TOP VIEW OF WING ARMORING

LATEST REVISION DATE 09-14	 Iowa Department of Transportation Highway Division
	STANDARD DESIGN - 44' ROADWAY, 3 SPAN BRIDGES CONTINUOUS CONCRETE SLAB BRIDGES NOVEMBER, 2006
	WING ARMORING DETAILS
APPROVED BY BRIDGE ENGINEER Norman E. McQuinn	J44-51-06

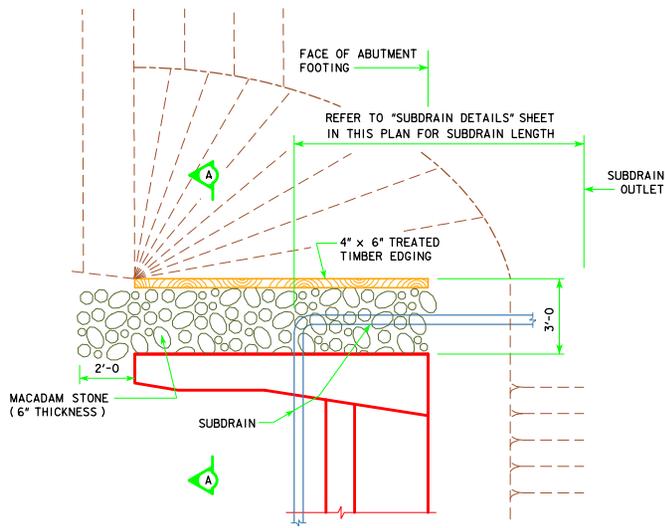
REVISED 09-14 - THE AREA OF MACADAM STONE WAS EXTENDED 2'-0" IN FRONT OF THE BRIDGE WING.
